Point Beach Nuclear Plant, Units 1 and 2
Dockets 50-266 and 50-301
Renewed License Nos. DPR-24 and DPR-27

License Amendment Request 261 Supplement 1
Extended Power Uprate

RESPONSE TO STAFF QUESTIONS

ENCLOSURE 1, QUESTION 5 DRAWINGS

BECH 6118 E-11 SH. 4

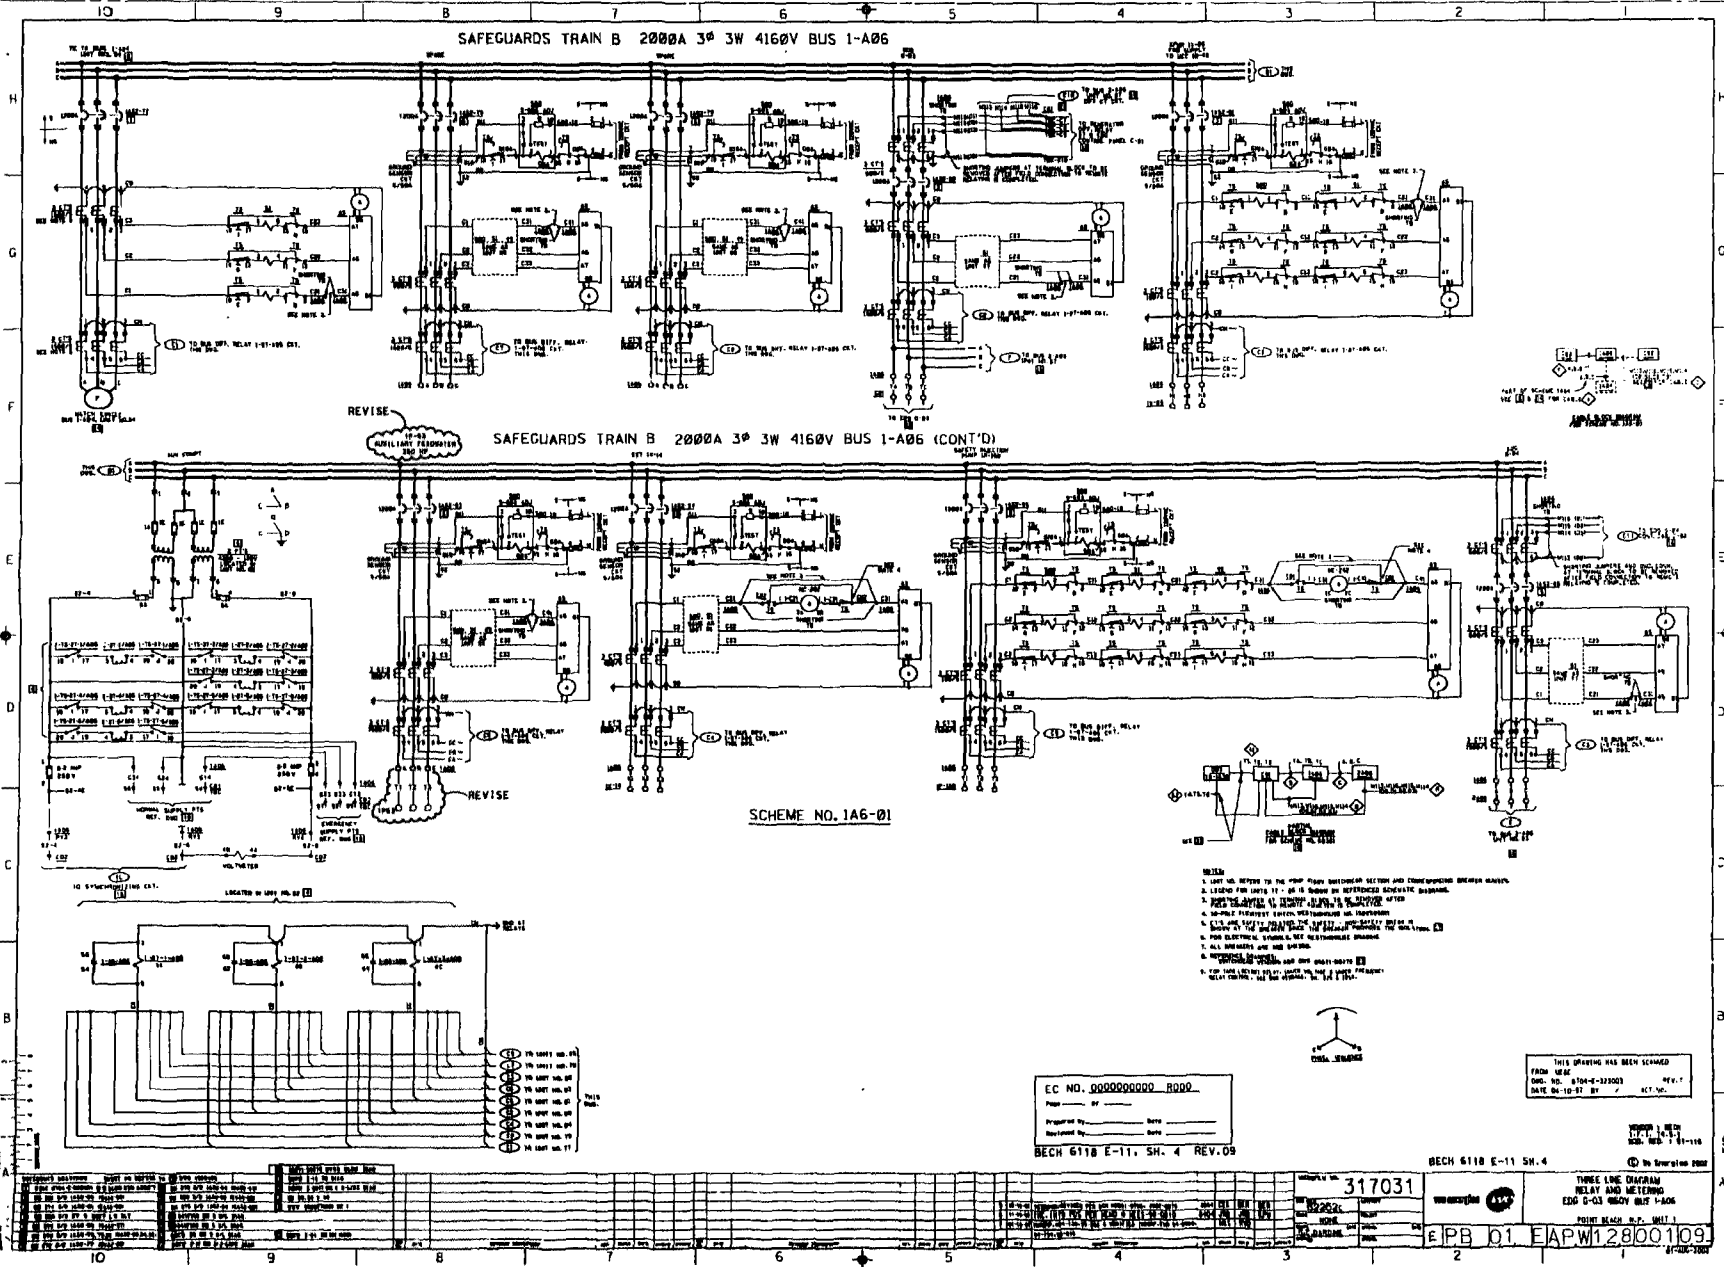
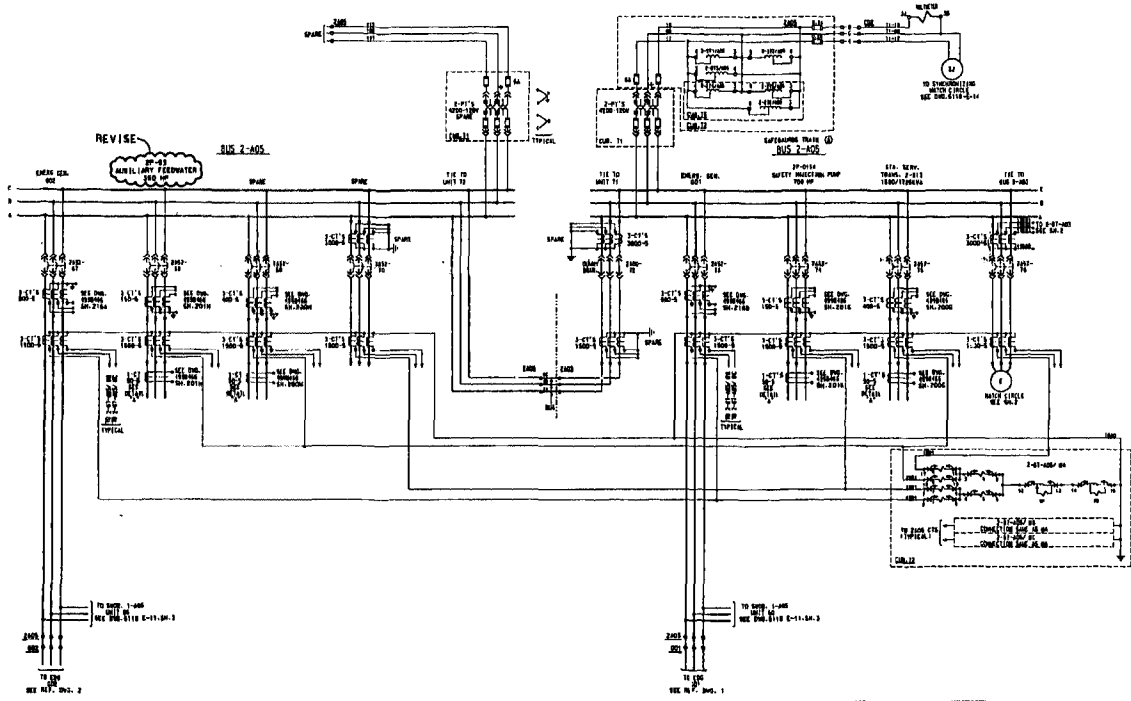
Provide an electrical one-line diagram and schematics that include the newly configured electrical design. Also, explain how the MDAFW cables are routed and how it meets the electrical separation and independence requirements.

PBNP electrical three line diagrams E-11 Sheet 4 and E-2011 Sheet 3 are provided in Enclosure 5. These drawings illustrate the connections of MDAFW pumps 1P53 and 2P53 to their associated power supply switchgear, 1A06 and 2A05, respectively. Modification in-process revisions of schematic drawings representing the current state of the design for the Unit 2 MDAFW pump 2P-53, and Standby Steam Generator (SSG) pump P38B of Unit 2 Trains A and B, respectively, are also provided.
